FIELD OBSERVATION REPORT

East Hardin Middle School, Hardin County Schools, Elizabethtown, KY 201752.01 -CA8

Report No: 14

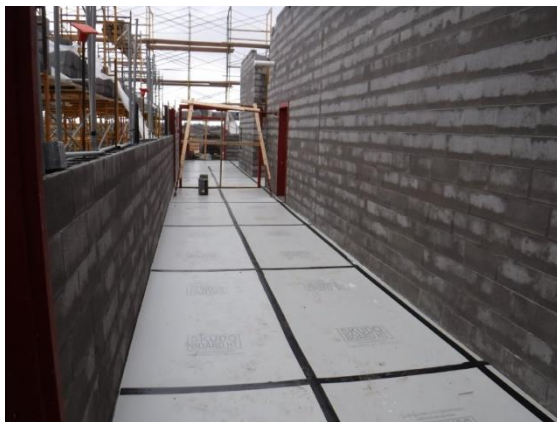
- j) Steel roof framing was in place for the roof over the north-south corridor to the east of the Gym.
